# Access Compliance Report

## Public Rights-of-Way

Intersection ID: 15242	Main Street: E_INDEPENDENCE_BV	Cross Street: N_WENDOVER_RD_RA	Location: SW
ADA ID: EC17416CCE49	Ramp Type: Perp	Initial Pass/Fail: Fail	Overall Compliance: No
Severity Score: 35			
Codes/Mitigation Info/Possible Solution		Field Measurements/Component Compliance

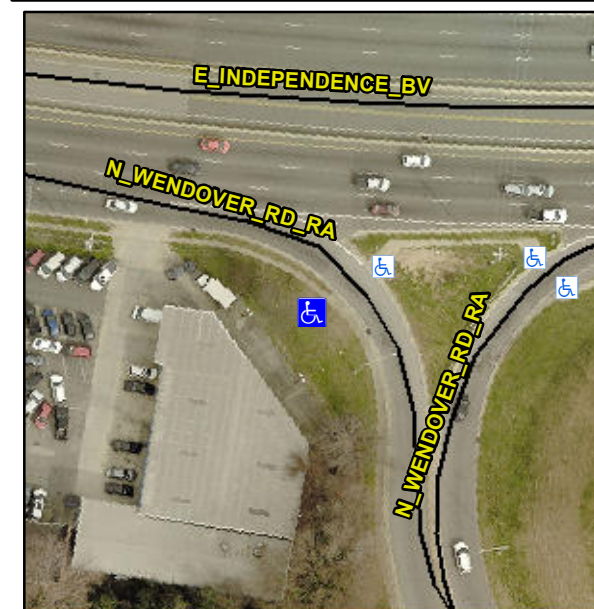
**Not Found, R304.5.1, R304.2.2, R304.5.3**

Compliance	Description	Data	Compliance	Description	Data
N/A	Ramp Length (in)	61.0	No	Ramp Slope (%)	13.3
No	Ramp Width (in)	38.5	No	Ramp XSlope (%)	2.6
N/A	Flare Type LT	N/A	N/A	Flare Type RT	N/A
N/A	Flare Slope LT (%)	N/A	N/A	Flare Slope RT (%)	N/A
N/A	Flare Traversable LT?	N/A	N/A	Flare Traversable RT?	N/A
N/A	Landing Length (in)	N/A	N/A	DWS Provided?	N/A
N/A	Landing Width (in)	N/A	N/A	DWS Contrast?	N/A
N/A	Landing Slope (%)	N/A	N/A	DWS Length (in)	N/A
N/A	Landing X Slope (%)	N/A	N/A	DWS Full Width?	N/A
N/A	Landing Curb? (Y/N)	N/A	N/A	DWS Offset (in)	N/A
N/A	Shared Landing?	N/A			
N/A	Gutter Ponding?	N/A	N/A	Gutter Slope (%)	N/A
N/A	Gutter Lip Ht (in)	N/A	N/A	Gutter X Slope (%)	N/A
N/A	Painted X Walk1?	No	N/A	Painted X Walk2?	N/A
	X Walk 1 Direction	To NE		X Walk 2 Direction	N/A
N/A	X Walk 1 Width (in)	N/A	N/A	X Walk 2 Width (in)	N/A
	X Walk 1 Slope (%)	4.8		X Walk 2 Slope (%)	N/A
	X Walk 1 X Slope (%)	2.0		X Walk 2 X Slope (%)	N/A

**Remove & Replace Entire Ramp.**
